STAFF RECOMMENDATION
3517 Richland Avenue
February 18, 2015

Application: New construction – addition; Setback determination
District: Richland-West End Neighborhood Conservation Zoning Overlay
Council District: 24
Map and Parcel Number: 10405041000
Applicant: Charles Rankin, Architect
Project Lead: Sean Alexander, sean.alexander@nashville.gov

Description of Project: The applicant proposes to enlarge the house with a rear addition that is both taller and wider than the original building.

Figure 1: Addition in relationship to existing house.

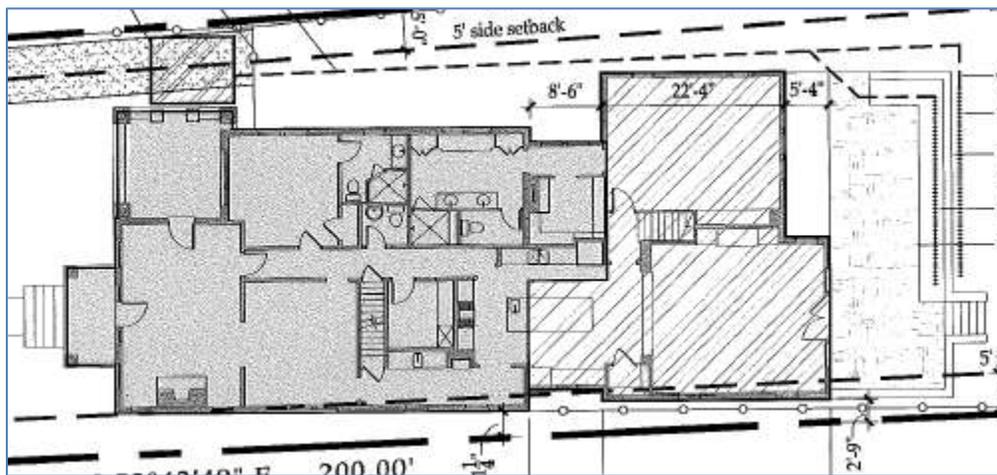
The addition will connect to the rear of the existing house with a hyphen that steps in from the original building on both sides and below the roof before stepping out seven feet (7') wider on one side and going three feet (3') taller than the existing structure. On the right side the addition will sit in two feet six inches (2'-6"), then extend back nine feet (9') before stepping back out ten inches (10"). On the left side the addition will originate at a corner that sits two feet (2') and eight feet (8') back from the primary wall and then step out nine feet (9') to the left.

It is generally not appropriate for an addition to be both taller and wider than an historic house. In this case, the project meets the requirements of the design guidelines to be wider because the house is shifted to one side of the lot, and it meets the guidelines to be taller because the additional height is minimal and will not likely be seen from the public right-of-way. Staff finds that in this case, the addition being both wider and taller is appropriate for the following reasons:

- The addition will be sufficiently distinguished from the historic house by the setbacks and the addition only gets taller approximately sixty feet (60') back from the front of the structure.
- The width of the taller gable is only twelve feet and does not extend the entire length of the addition.
- The angled shape of the lot, compared to the layout of the house impedes the ability to continue an addition towards the rear without further encroaching in the right setback and the grade of the lot rises in the back, naturally pushing the rear addition up.

Staff finds that the height and width of the proposed addition is appropriate and that the project meets sections II.B.1.a. and b. of the design guidelines.

site plan

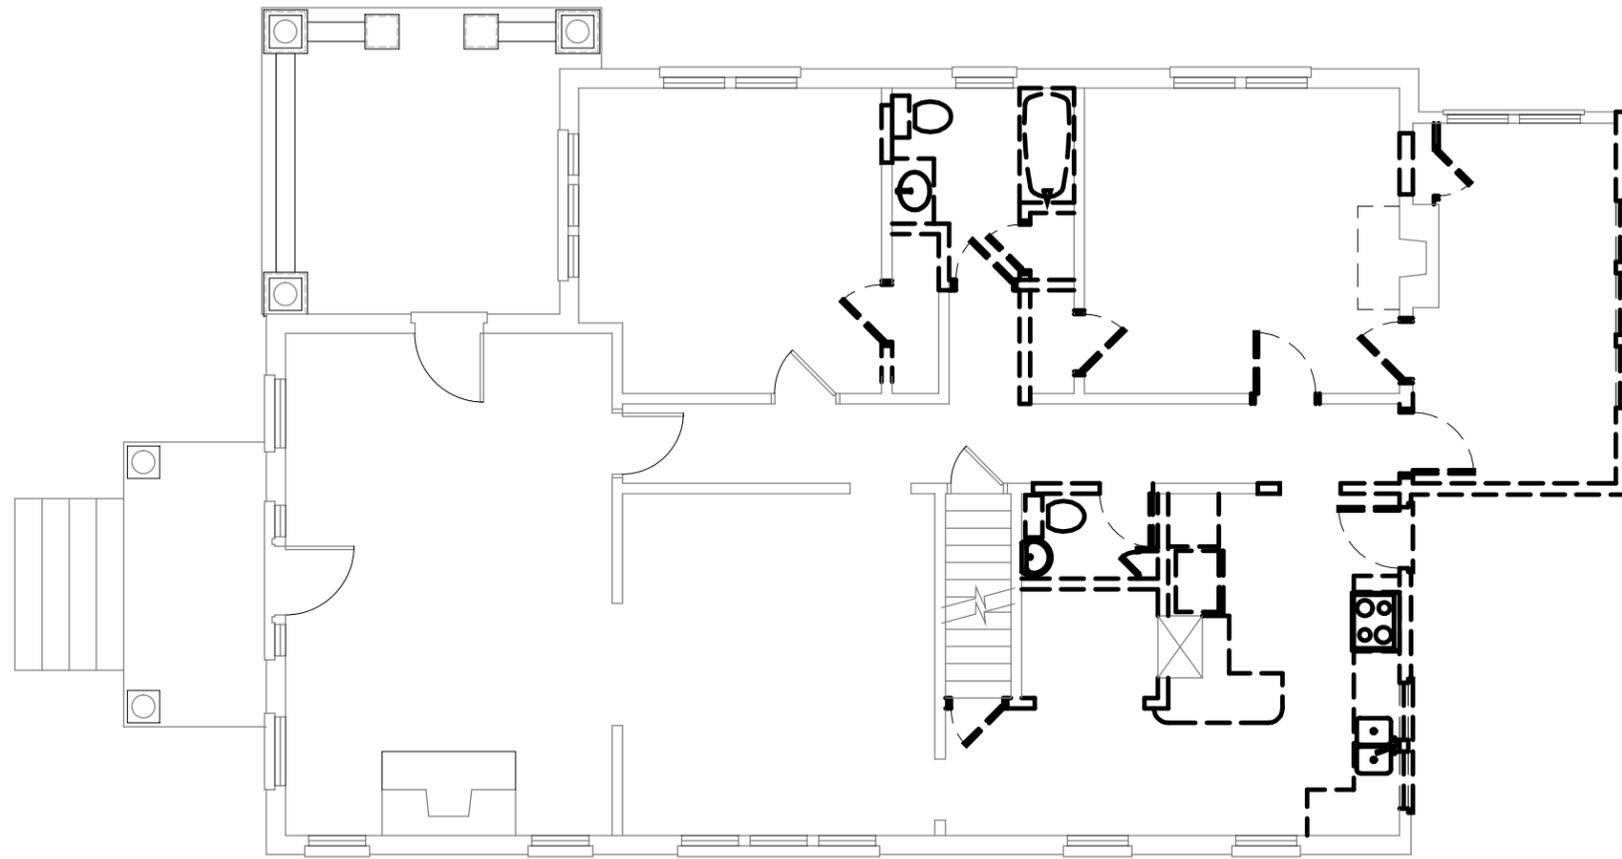
Although the addition sits inside the width of the house on the right side, the rear corner would not meet the standard setback requirements because the side property lines are angled. Staff finds the proposed location, which comes to within three feet three inches (3'-3") from the property boundary, to be appropriate because the addition sits in from the side of the historic house, the setback is greater than that of the original structure and because of the angle of the lot lines.

On the left side, the addition will have a setback of nine feet (9'). This is equal to the setback of the existing house on the left, and meets the standard setback requirements.

Staff finds that the addition to 3517 Richland Avenue will not disrupt the rhythm of spacing established by historic buildings on the street and that the project will meet section II.B.1.c of the design guidelines.

front elevation

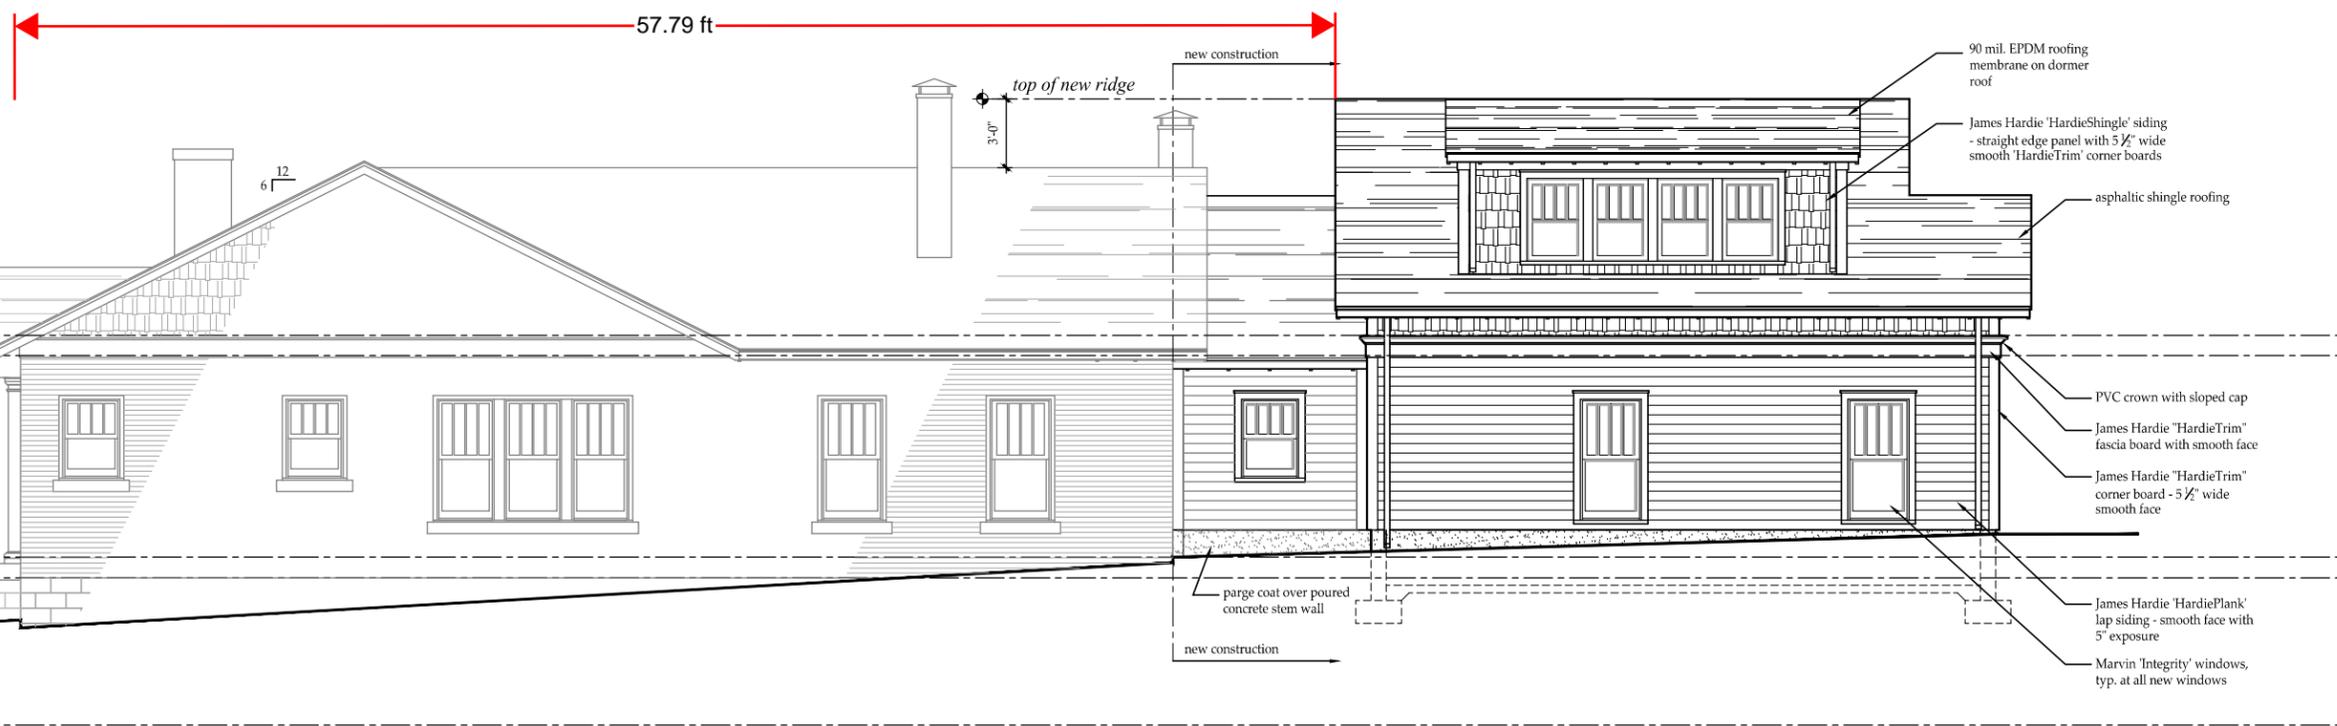
No major changes to the historic house's materials were indicated on the drawings. The addition will primarily be clad in smooth face cement fiberboard with a reveal of five inches (5"), with cement-fiber shingle siding as an accent material in the dormers. The trim will be wood and cellular PVC (Azec Brand PVC has been approved for trim and cornerboards in this Neighborhood Conservation Overlay previously). The foundation will be split-faced block and poured concrete with a parge-coat finish, and the roof will be architectural fiberglass shingles in a color to match the existing roof. The windows will be fiberglass-clad wood, and staff asks to approve the final window and door selections prior to purchase and installation. With the staff's final approval of the windows and doors, staff finds that the known materials meet Section II.B.1.d of the design guidelines.

The roof of the addition will have a rear-facing gable with shed-roofed dormers on both sides sitting in from the first story walls below. The primary roof of the addition will have a 5:12 pitch, which lower than the 6:12 pitch of the original roof but not so different as to be incompatible. The shed-roofed dormers on the addition will have lower slopes (1.5:12), which is not an uncommon pitch for dormers. Staff finds that the roofs of the

No changes to the window and door openings on the existing house were indicated on the plans. The windows on the proposed addition are all generally twice as tall as they are wide, thereby meeting the historic proportions of openings. There are no large expanses of wall space without a window or door opening. Staff finds the project's proportion and rhythm of openings to meet Section II.B.1.g.

Staff recommends approval of the proposal to construct a rear addition at 3517 Richland Avenue with the condition that the window and door selections are approved by Staff, finding the application would meet the applicable design guidelines for the Richland-West End Neighborhood Conservation Zoning Overlay.
